Service-News Tectalk Freestyle

Problem:

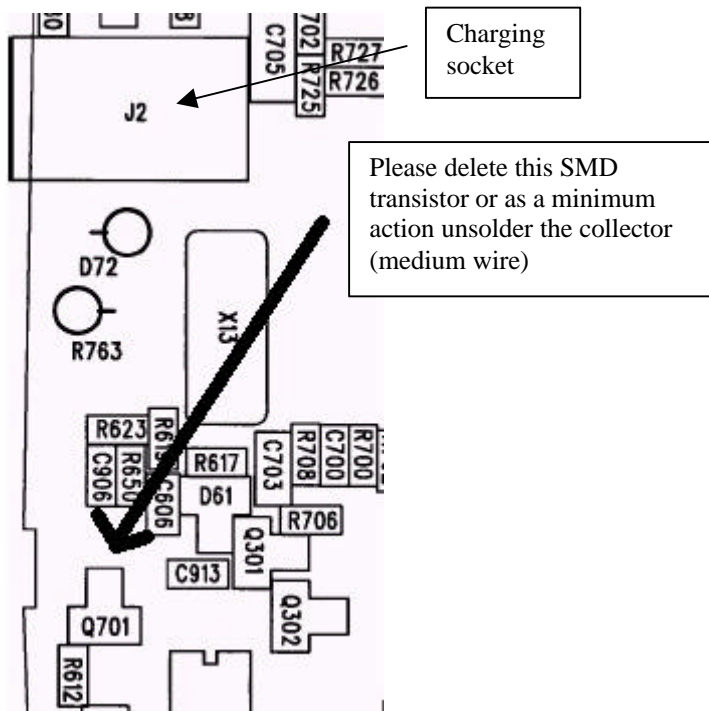
Radios of the first shipment February 2001 may have a missing function:

Roger Beep (described on page 10 of the german user manual, but not mentioned in the english manual) cannot be programmed.

In addition to this phenomena, the **VX** display Icon **remains blinking for some seconds** after programming and confirming the setting by PTT key.

Caused by a misunderstanding, the factory has inserted an additional transistor switch to inhibit Roger Beep function.

If Roger Beep beep is desired, it is possible to delete the transistor Q 701. The SMD part is easy to find near to the charging socket on the main board. The transistor can be deleted, as minimum action we recommend to unsolder the collector (medium contact).

All Tectalk Freestyle will be shipped with programmable Roger Beep Function from March 2001
